OEI® *Product Bulletin*

RE: Activ8 – Villa Modules now with USB

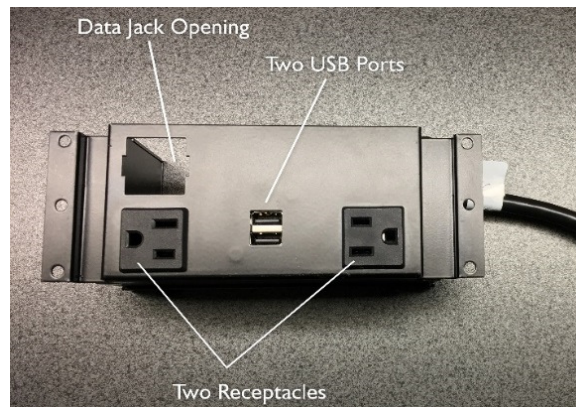
Effective September 27th, all Villa modules will include two USB ports, two simplex receptacles, and one data opening (customer supplied data jack). If the customer requires two data openings, they can be ordered through Custom Options but will not include the USB ports.

Model numbers to the Activ8 modules will not be effected with this running change (AC8VMC.XX/AC8VMN.BL).
